**RE: PROPOSED ALTERATIONS AND ADDITIONS
LOT 22 DP 805356
No.9 KILLARNEY CRESCENT
SKENNARS HEAD**

8.1 DA 2014/91 - 9 Killarney Crescent, Skennars Head.DOC

PROJECT:
PROPOSED ALTERATIONS & ADDITIONS
LOT 22 DP 805356
No.9 KILLARNEY CRES
SKENNARS HEAD

SHEET TITLE:
DEVELOPMENT APPLICATION
PROPOSED SITE & FLOOR PLANS

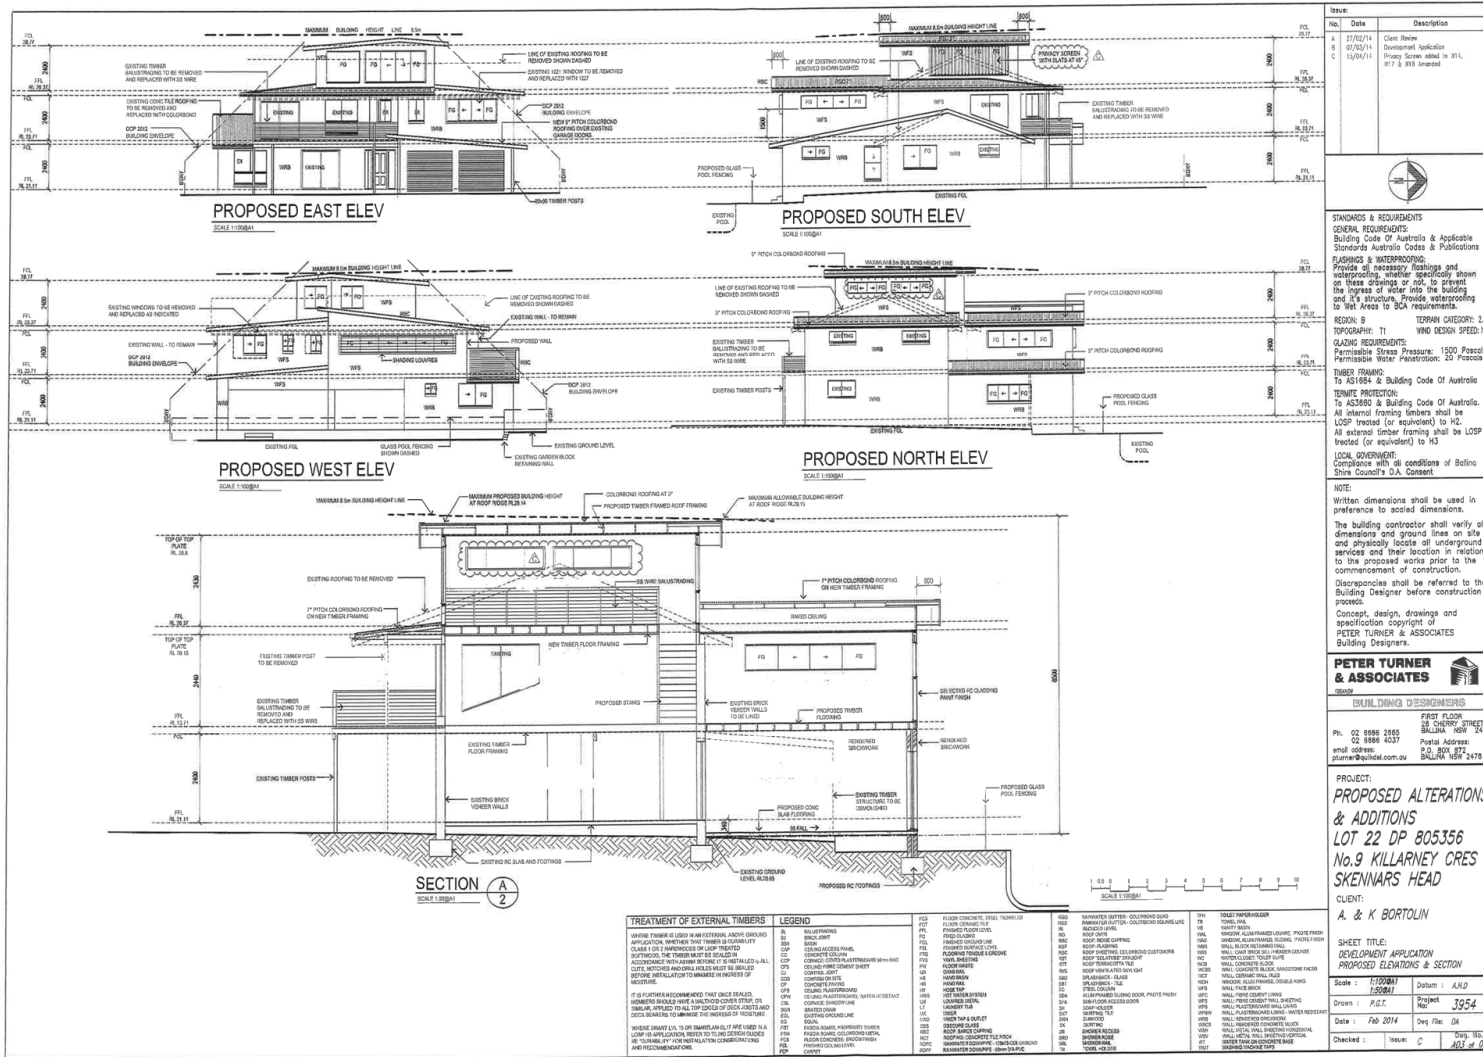
- 1) One of the issues that we lodged with our objection to this development was that of privacy. The loft (3rd storey) will look down directly into our master bedroom. A letter dated 28th April 2014 regarding alterations the architect has chosen to make by the addition of privacy screens to the windows of the southern elevation of the loft area and changing the height of the windows on the northern elevation was forwarded to us by Ballina Shire Council.

We do not consider that by changing the window size to our side (north elevation) of the proposed loft remedies the privacy issue. If this development is approved we would like privacy screens to be installed to the windows of the northern elevation as well.

- 1) We do not agree with the second storey (loft). It is in affect a 3rd storey. We understand that there is a Building Code limiting the height of residences but fail to understand where the designer has based his assumptions to design this development. There appears to be no consideration for the building envelope to the front boundary and by simple calculations $1.8 + 6.0 = 7.8$ this is considerably less than the 8.5 proposed building height. Using existing ground levels the proposed loft fails to comply with the building envelopment.

The planned loft has windows on all sides and will look down into our master bedroom and ensuite. We consider this development would be an invasion of our privacy as well to all surrounding properties.

- 2) The proposed skillion roof over the existing garage doors will encroach into the 6 metre building setback alignment. The design of the subdivision in this general location was created so that people who paid a premium for their land were afforded the opportunity of some ocean view. By allowing any encroachment would set precedence for continued encroachment into the designed building alignment. This proposed structure serves minimal purpose. The design could easily be changed to comply with the correct alignment.
- 3) The original building standards set percentages and types of materials to be used for construction and these appeared to not have been adhered to.

- 4) The designed pitch for the roof appears to have been reduced to the absolute minimum for this development to try to comply with the 8.5 metre height. The proposed East Elevation clearly shows the finished ceiling height on the LHS as being above the roof. Using the existing ground level and correct building room heights it is impossible for this development to comply with the 8.5 height limit. If this development is to proceed a survey should be carried out during construction and if it does not comply (as I expect it physically can not) then the loft construction should not proceed.

It is very unclear if survey points have been taken from natural ground level.

On numerous occasions the abbreviation **FGL** has been used which means ground level after the completion of excavation and earthworks. Does this indicate this measurement has been taken from existing fill height and not original ground level as required?

We request a proper contour plan be supplied, showing natural ground level at least at the 4 corners of the new development at the boundary points.

The reason for this is to show clearly the 1800mm vertical measurement then the 45% angle that is taken from that, is from the point of original ground level and that none of the proposed addition is encroaching on the building envelope and is not over the 8.5m level at any point.

We request this because the submitted western and southern elevations are misleading as western elevation n/west corner ground level is quite different to s/west corner ground level and unless correct ground levels are supplied the building envelope could change dramatically.
